# UNITED STATES PATENT AND TRADEMARK OFFICE

APPLICATION NO.	FILING DATE	FIRST NAMED INVENTOR	ATTORNEY DOCKET NO.	CONFIRMATION NO.
10/536,616	05/26/2005	Piotr Jedrzejewski	P16590-US1	7102
27045	7590	11/07/2006	EXAMINER	
ERICSSON INC. 6300 LEGACY DRIVE M/S EVR C11 PLANO, TX 75024			GLENN, KIMBERLY E	
			ART UNIT	PAPER NUMBER
			2817

**Office Action Summary**

FIG. 3

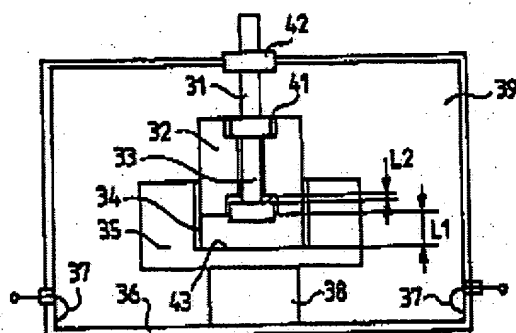
Särkkä disclose a dielectric resonator comprising adjustment element wherein the adjustment element comprises adjustment bodies 32 and 33. The adjustment

bodies each have a non-uniform geometric shape. Inherently, since the adjustment bodies have non-uniform shape the distribution of dielectric constant will be non-uniform along the length of the adjustment bodies. The resonance frequency varies as a non-linear function of the adjustment distance. The adjustment bodies vary along an axis of adjustment element displacement. The adjustment body 33 has a hollow section wherein the other adjustment body 32 and the adjustment mechanism are attached. The effective tuning area is within a hollowness of the resonator 35. The axis of adjustment element displacement is arranged centrally through the resonator hollowness.

FIG. 2

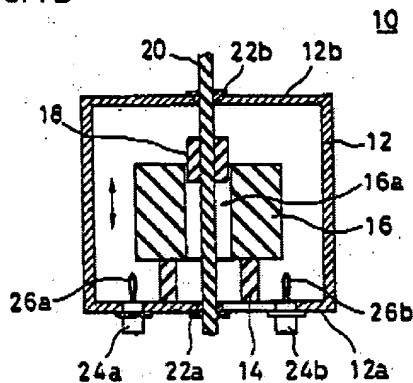
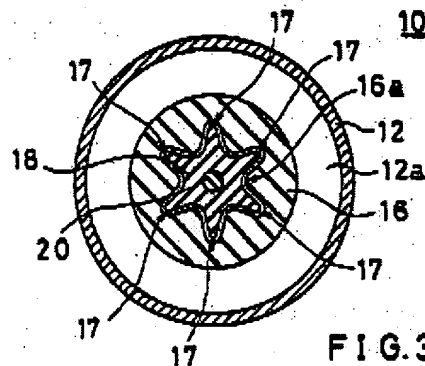
Ishikawa et al disclose a dielectric resonator comprising tuning mechanism comprising tuning unit (18) and supporting axis (20). The tuning unit has a non-uniform shape. The tuning unit has a high dielectric constant while the support axis as a low dielectric constant. Inherently, since the tuning unit has a non-uniform shape the distribution of dielectric constant will be non-uniform along the length of the tuning unit.

The tuning element varies along an axis of the supporting axis. The tuning unit has a hollow section wherein supporting axis is attached. The effective tuning area is within a hollowness 16a of the resonator 16. The axis of support axis is arranged centrally through the resonator hollowness.

FIG. 12

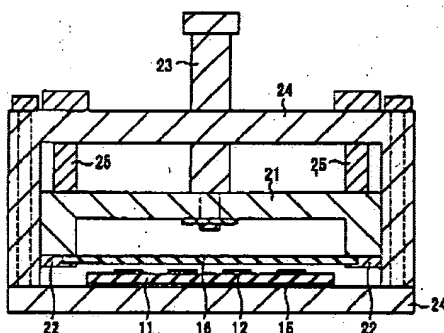
Terashima et al disclose high frequency device comprising resonating elements 12 and a tuning mechanism comprising dielectric plate 16, a metal holding jig 21 and lift jig 23. The dielectric plate, the metal holding jig and the lift jig have geometric shape. The metal holding jig and the lift jig will have dielectric constant different from the dielectric constant of the dielectric plate. The effective tuning area is outside the resonating elements.
